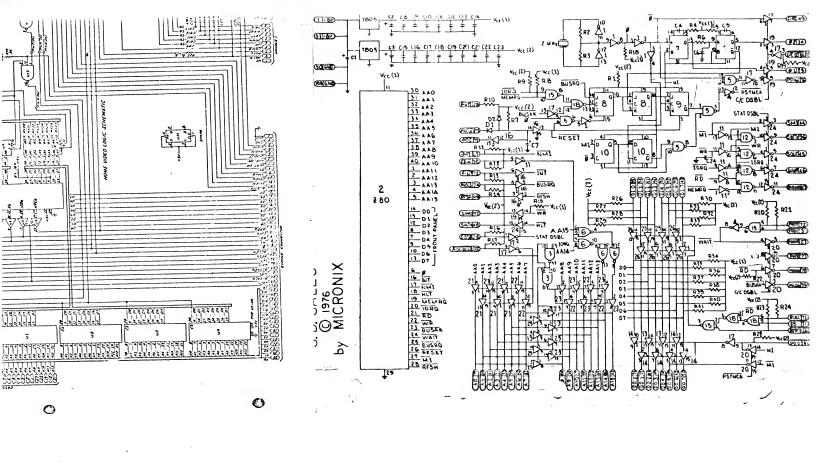
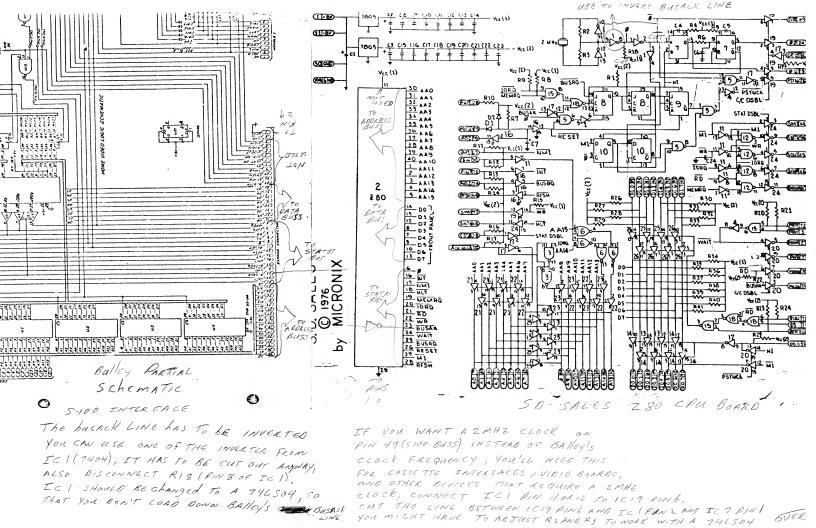
This is an outstanding idea with many possibilities - in thery at least stary I didn't think of it. There appears to be at least three possibly problems, I havened. The first is that PSYNC is not squeed to the CPV clock, possibly causing problems with some S100 boards. The second deals with the fact that the BALLY WAIT line cannot be connected to a derive capable of sourcing current as it appears IC4 will do. The third deals will the receivity of providing BALLY with the carrest signals on the BUZOFF him.

None of these problems are insummentally, but may require extensive modifications to the S-D sales CPV board to circumsent.

EXSPANSION BUS ARE MADE BY ANSLEY, THE CONNECTORS

PART X IS 609-5005, BILOGS IN CANADA. IT'S HARD

TO USE A CONNETOR ON THE CRU BOARD SINCE IT ISN'T

A PIN FOR DIN MATCH TO BALLEY'S BUS. THE EASIEST

WAY TO CONNECT TO THE CRU BOARD IS TO REMOVE

RIBBON CABLE DIRECTLY TO THE CRU BOARD
